## TECHNICAL BULLETIN 008 July 2014

Connecting rod screws p.n. 1801.01, 1801.05 and 1801.32  
Connecting rods p.n. 0100.00, 0100.01, 0100.08 and 0100.10

Locking  
adhesive

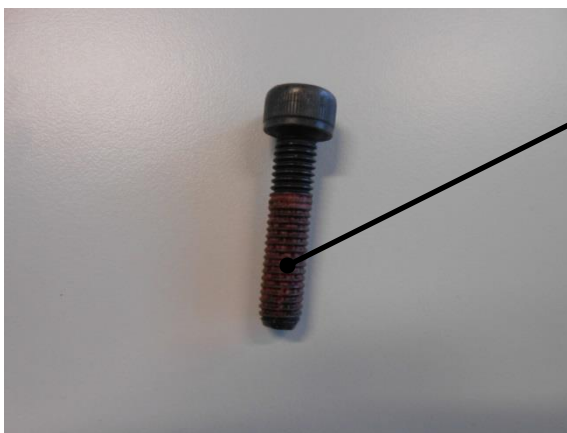
The screws and nuts have been changed to avoid unscrewing under severe vibrations. The locking adhesive is dry-to-touch and it is activated during assembly and cures to form a tough polymer that eliminates movement between the threads and provides a total seal. The new screws are interchangeable with the old ones and all part numbers did not change.
